ACCESS REPORT

PROJECT: **Hickson Road Upgrade, Stage 3 & 4**
PROJECT NO: **GDL230396 and GDL240556**
PREPARED FOR: **Lendlease and Infrastructure NSW**
REVISION: **C**
DATE: **31.10.2025**

The items in the table below have been noted as items of relevance at this stage of the review. The items that have been considered non-compliant require further review against the detailed design. refer to Appendix B for marked-up comments on drawings.

DRAWING NO.
L_1001

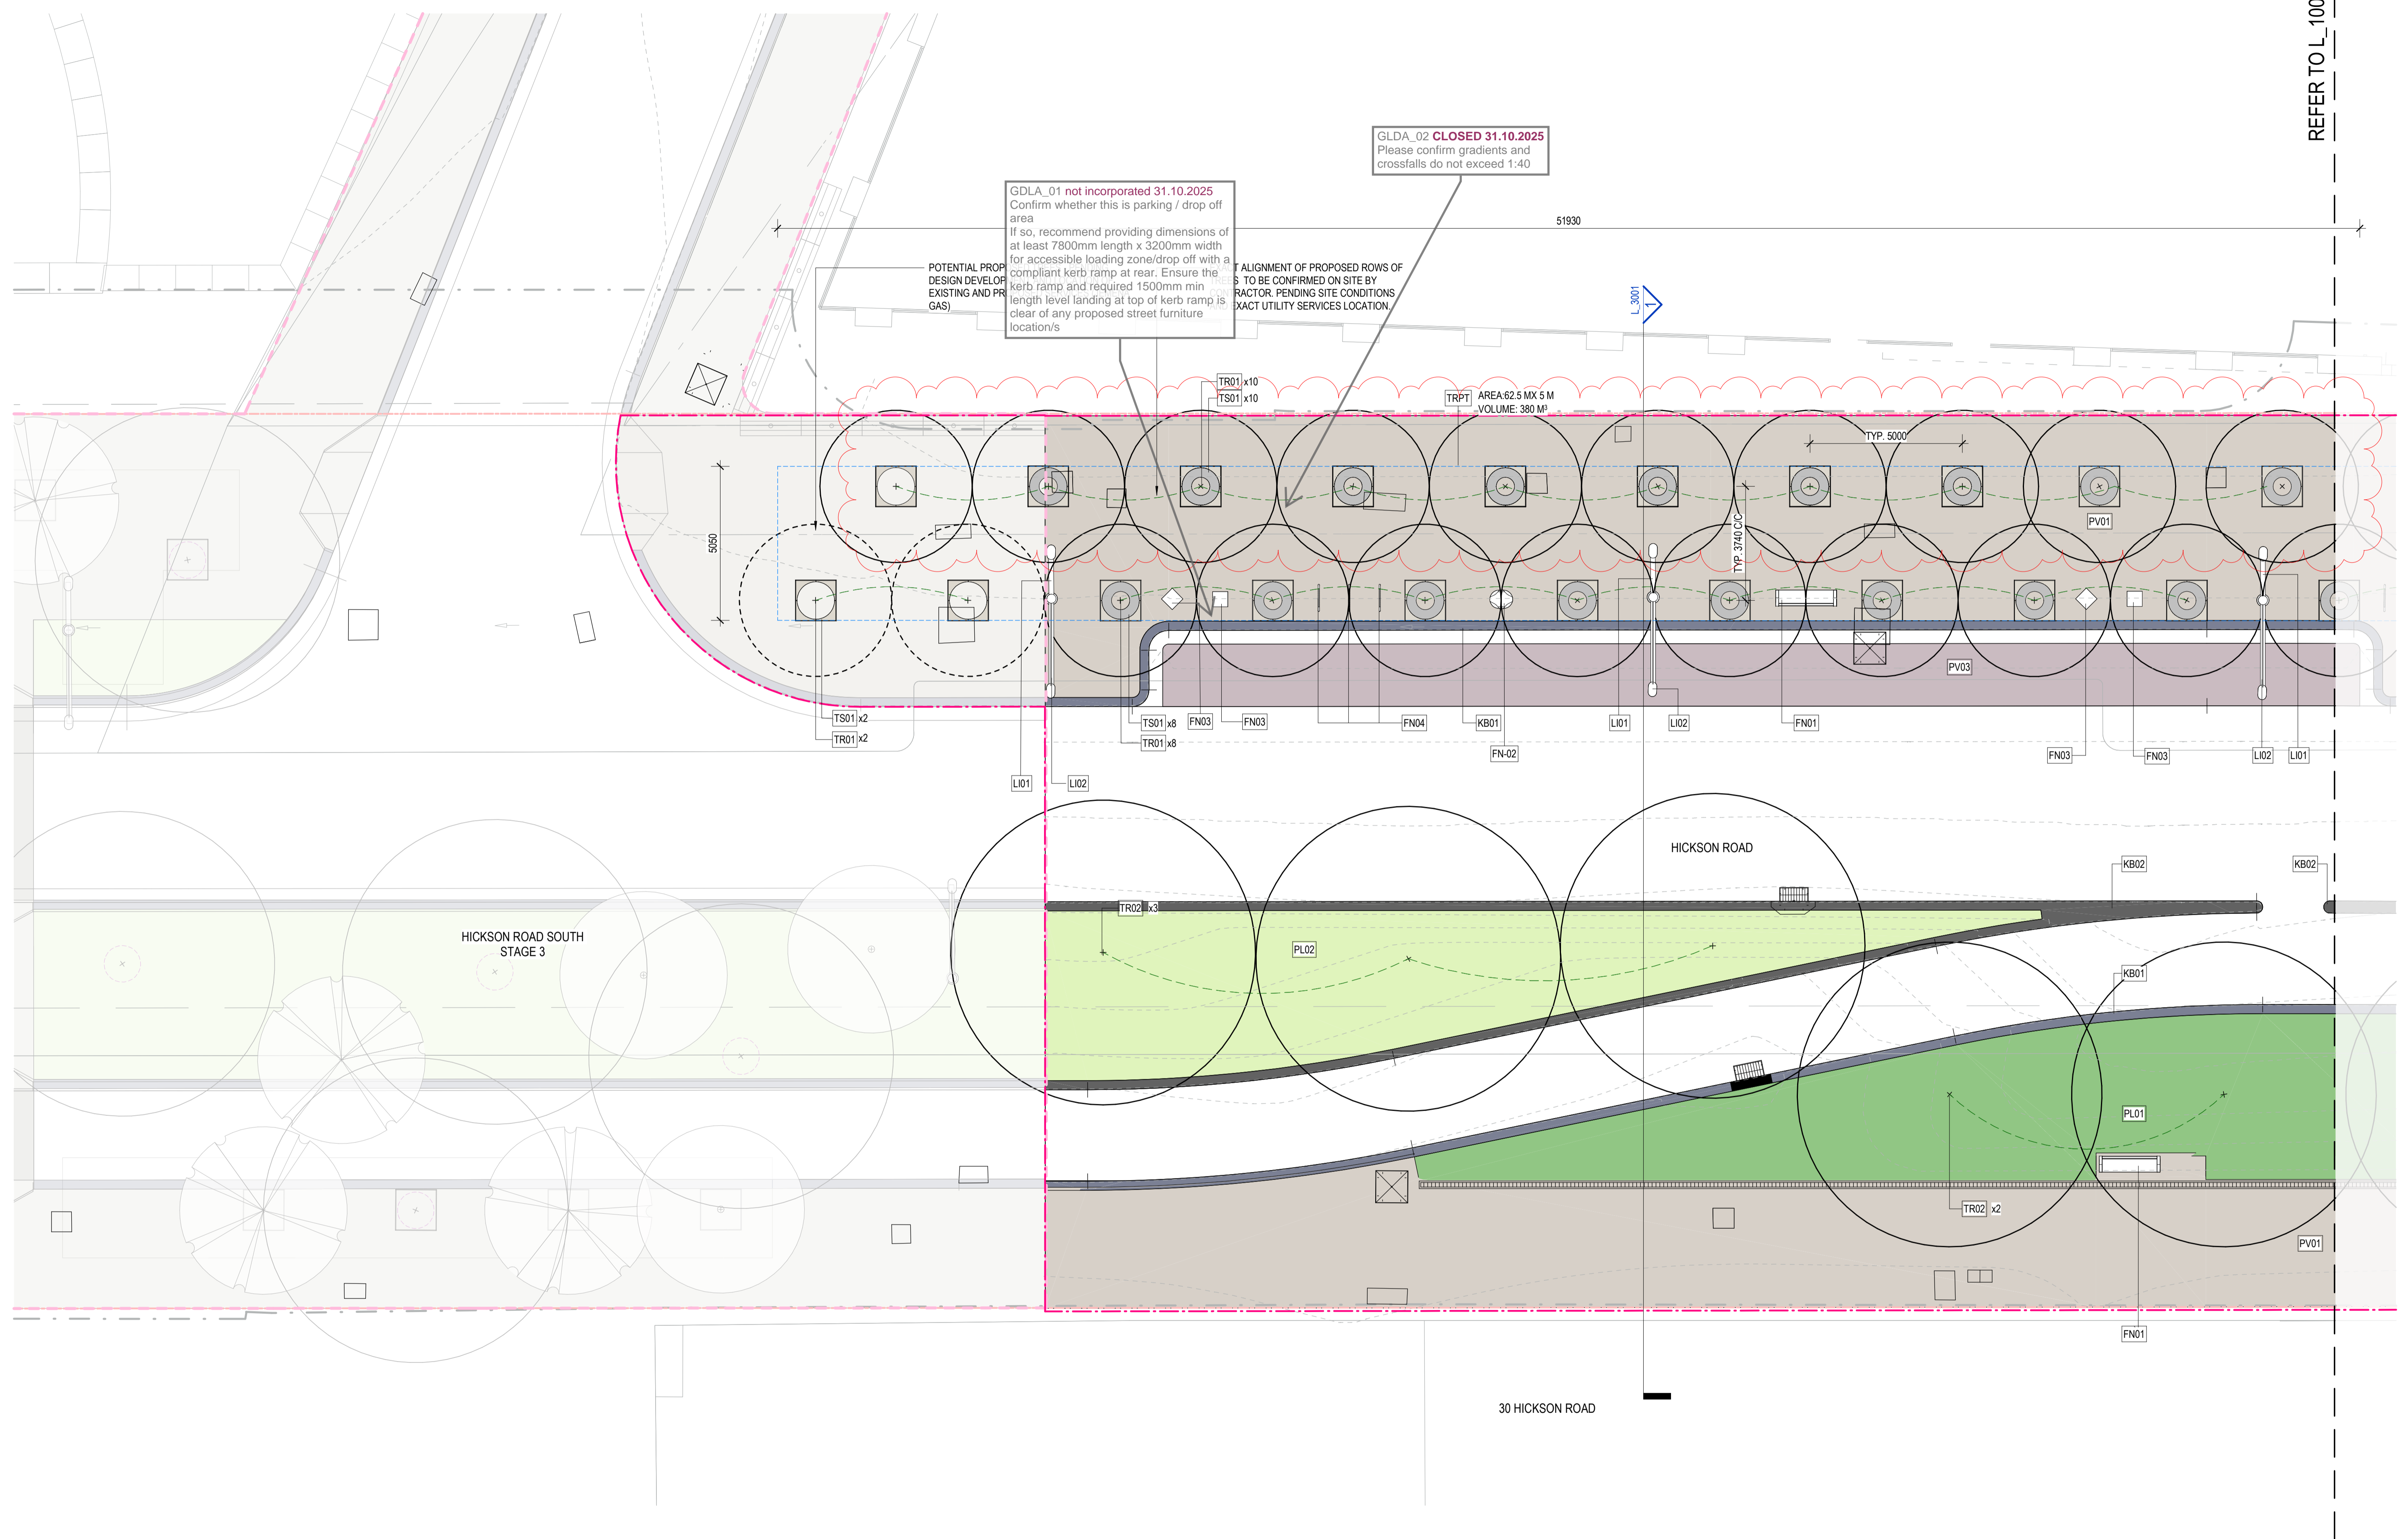
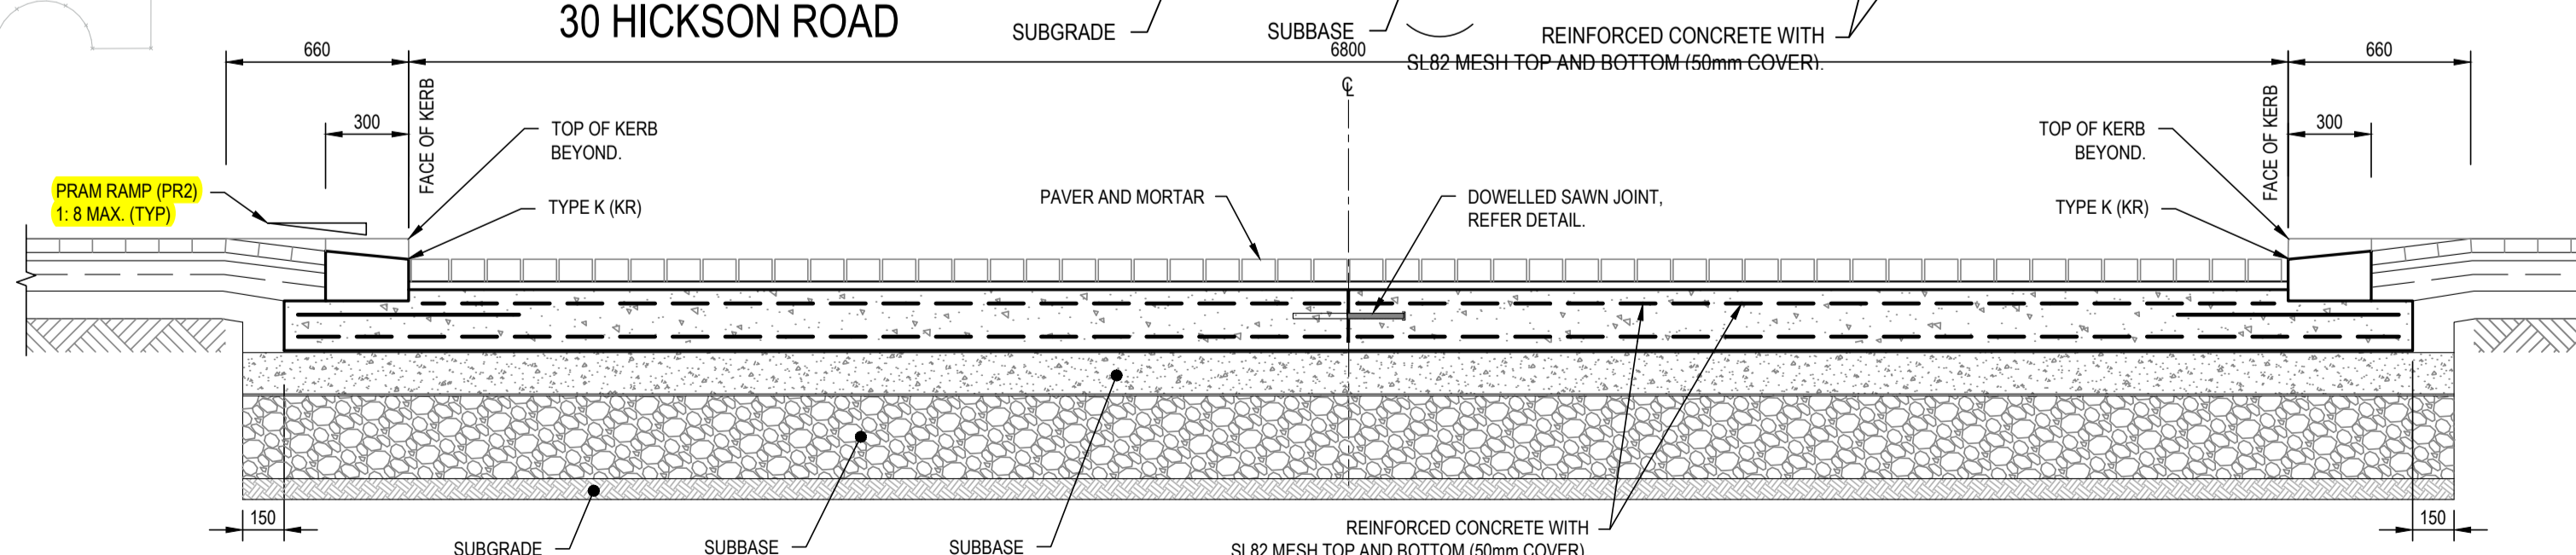
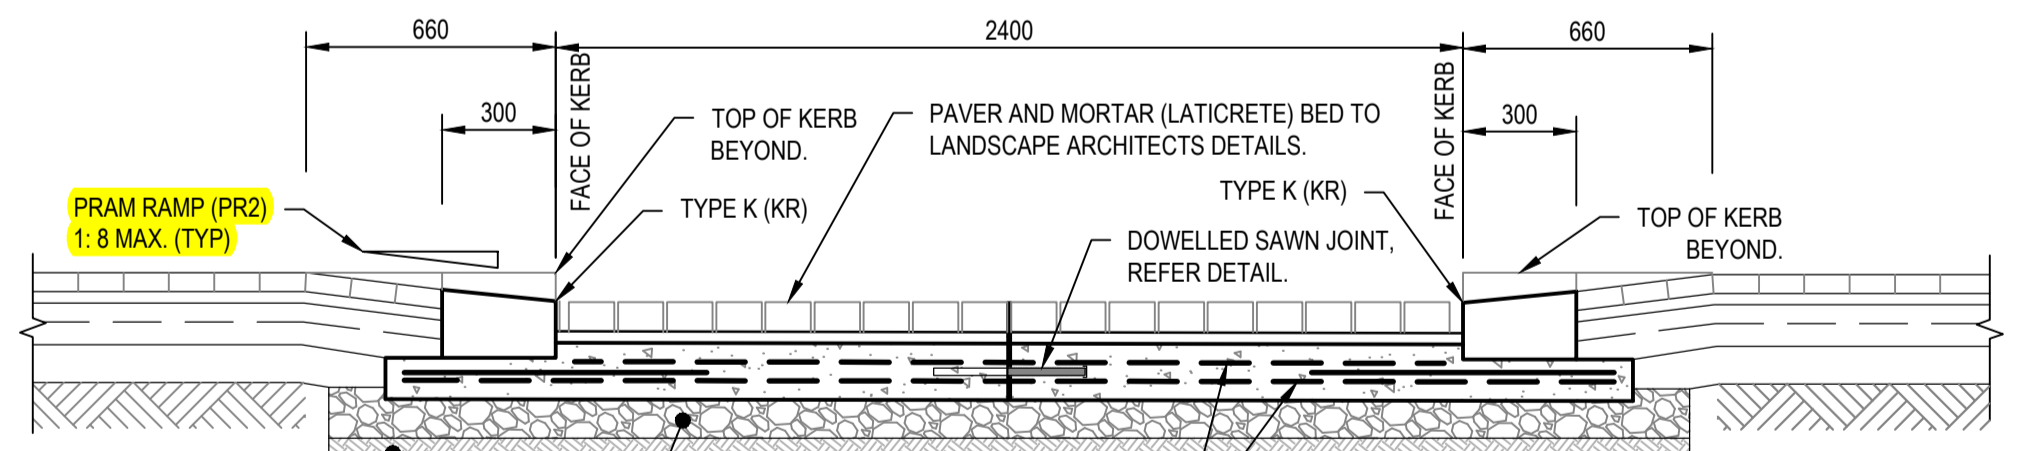
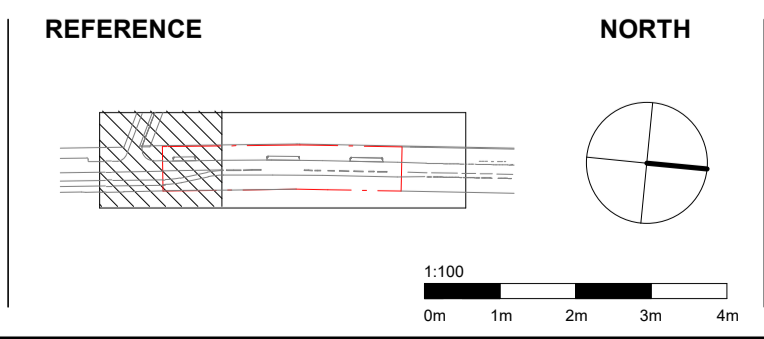
GDLA_01B CLOSED 31.10.2025
 Recommend that top and base of kerb ramps are reoriented to be perpendicular with path of travel to cross the road. Refer AS1428.1 Fig 23b
 Kerb ramp to have between 1:8 - 1:8.5 gradient to assist people with vision impairment locate and be informed of change in environment (without needing to use warning TGSs)

GDLA_08 CLOSED 31.10.2025
 The angle of splayed portions are to be 45 degrees - too shallow as it is currently drawn. Ensure other geometries incl. gradient are compliant with the Standard. (AS1428.1 Cl 7.7, Fig 24)

GDLA_05 CLOSED 31.10.2025
 Will pedestrian crossing be raised / linemarked? Ensure linemarking meets slip requirements

GDLA_06
 TGSs to start at building line

DRAWING NO.
L_1002

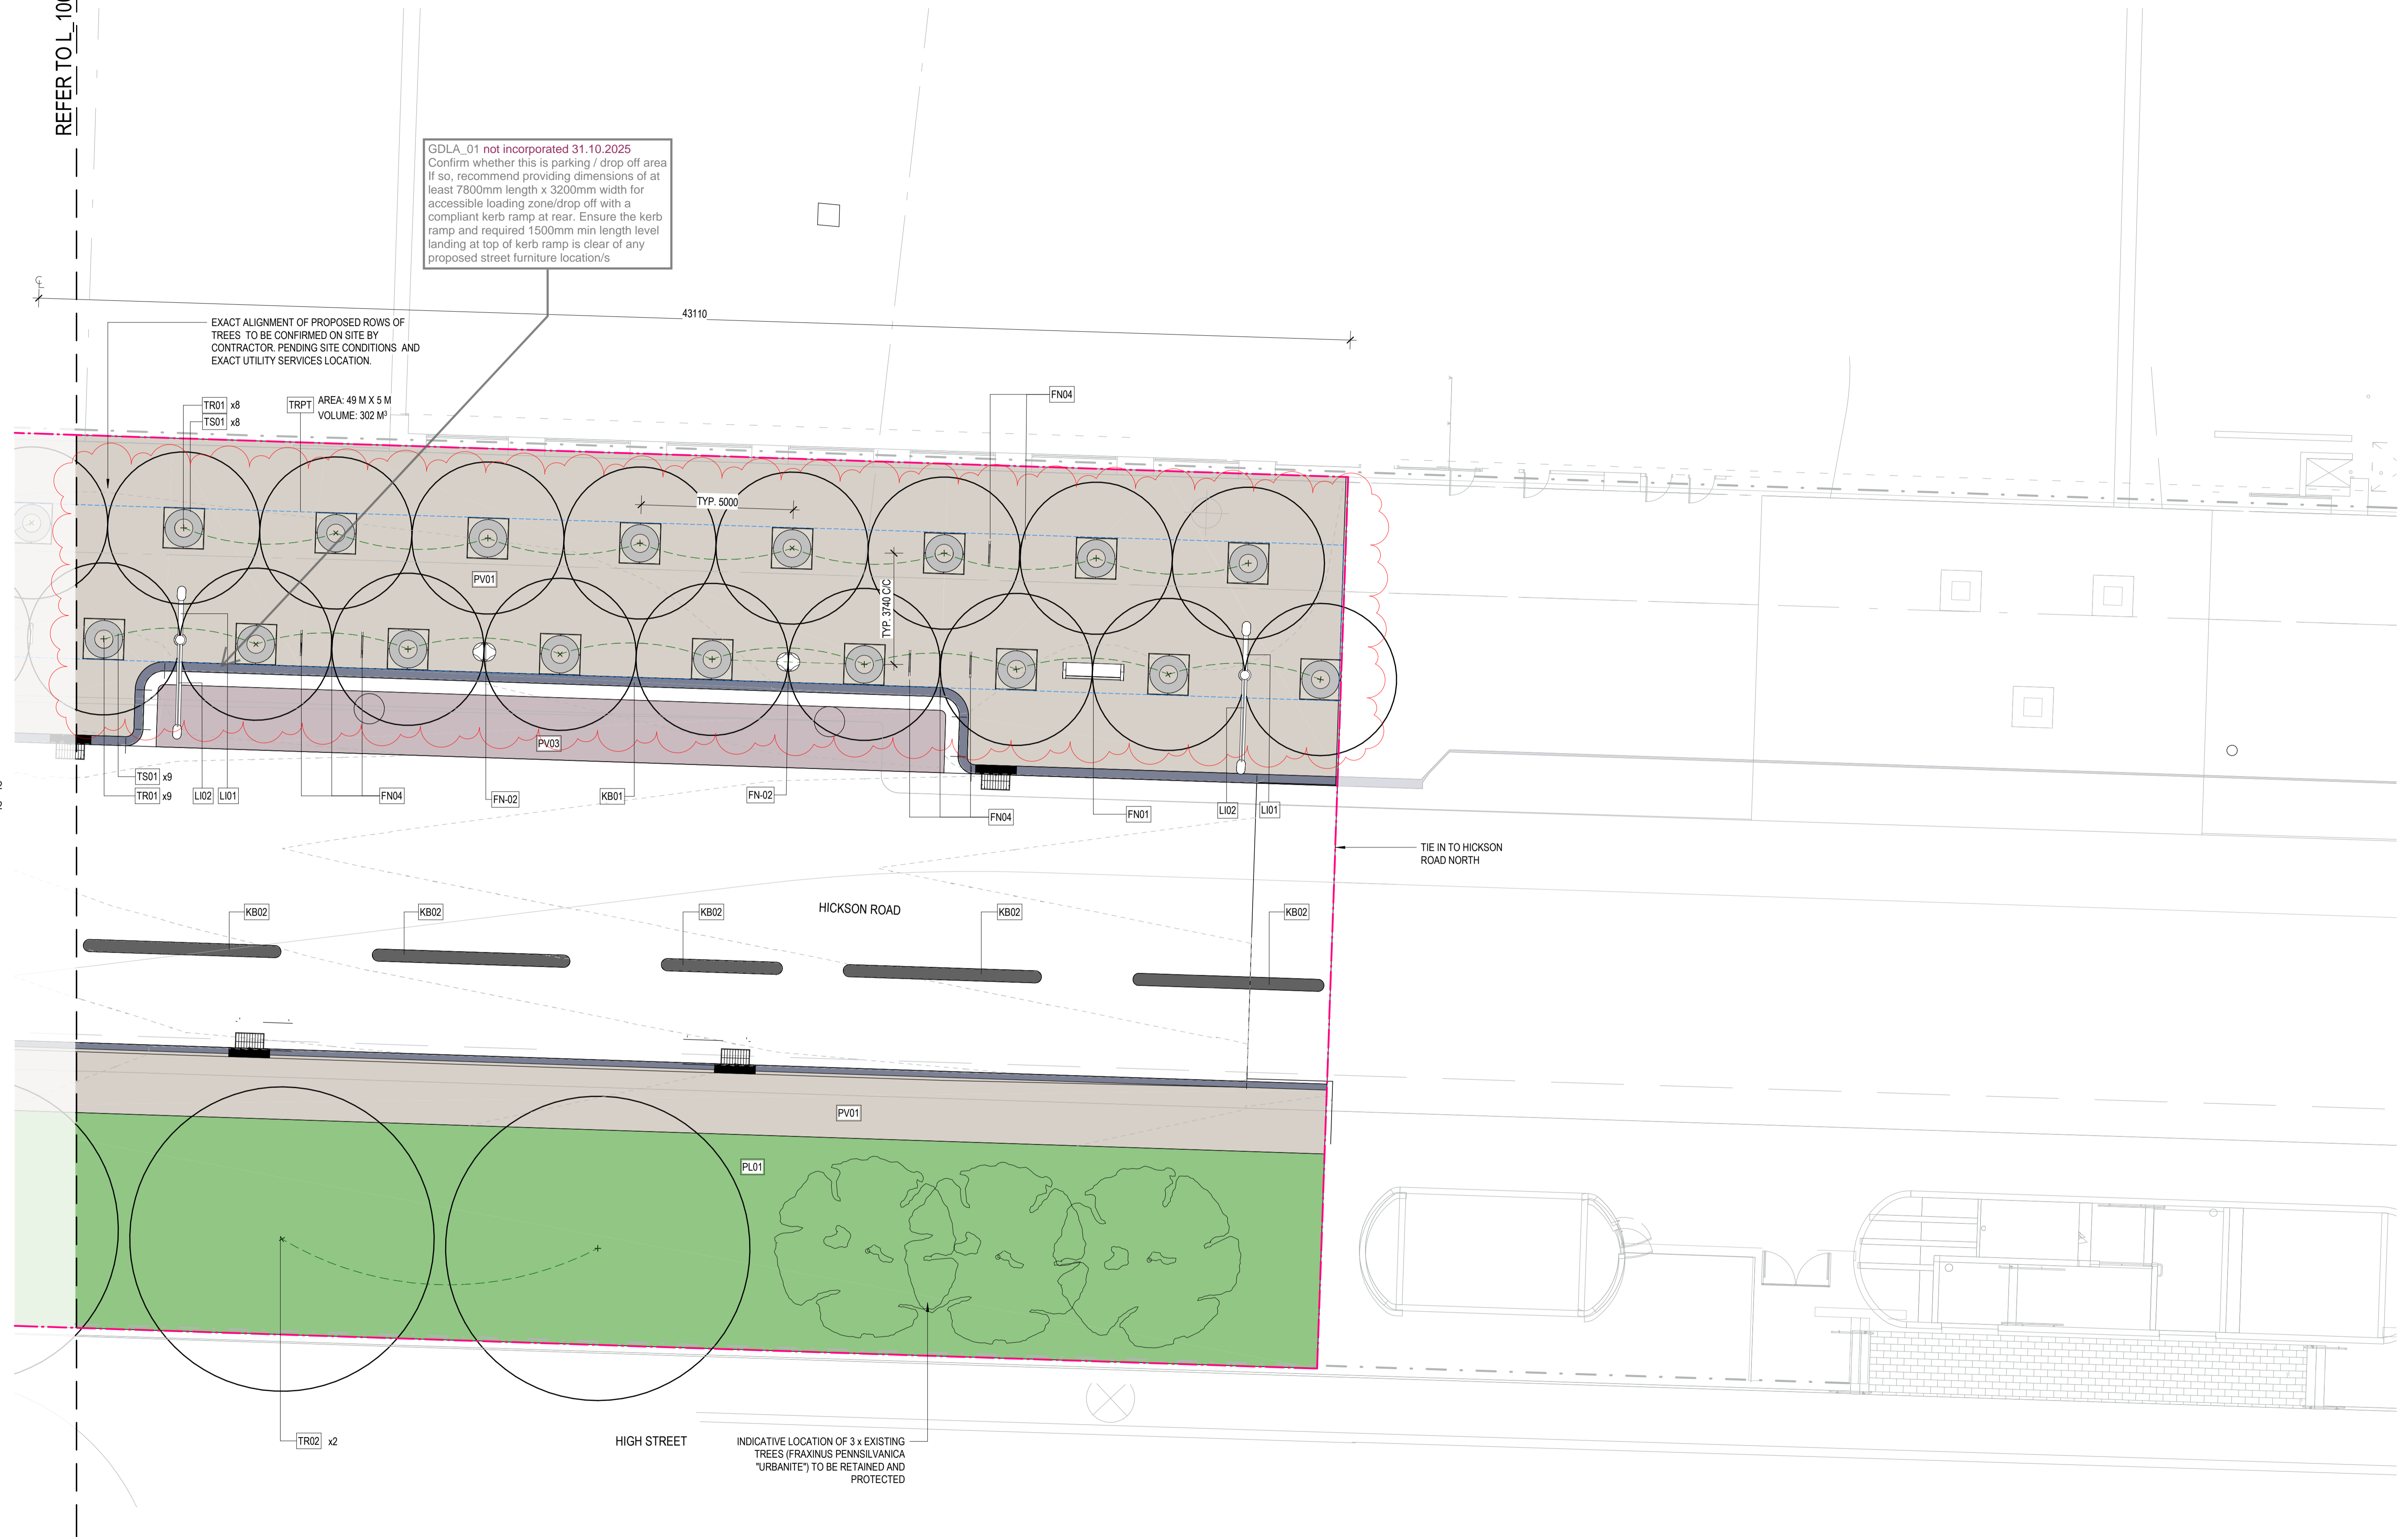
GDLA_01 not incorporated 31.10.2025
 Confirm whether this is parking / drop off area
 If so, recommend providing dimensions of at least 7800mm length x 3200mm width for accessible loading zone/drop off with a compliant kerb ramp at rear. Ensure the kerb ramp and required 1500mm min length level landing at top of kerb ramp is clear of any proposed street furniture location/s
